Access Compliance Report

Public Rights-of-Way

(Curb Ramps)

Intersection ID: 31122	Main Street: MILLSTREAM RIDGE DR	Cross Street: N/A	Location: SE
ADA ID: 193D685C8932	Ramp Type: BlendTrans1	Initial Pass/Fail: Fail	Overall Compliance: No
			Severity Score: 21.25

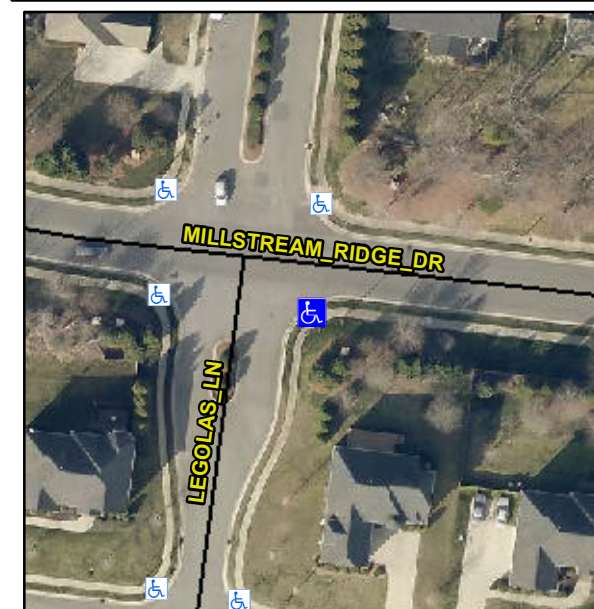
CURB GAP 1.0

R304.5.1, R304.5.3

Remove & Replace Curb Ramp With Two New Directional Ramps or Equivalent.
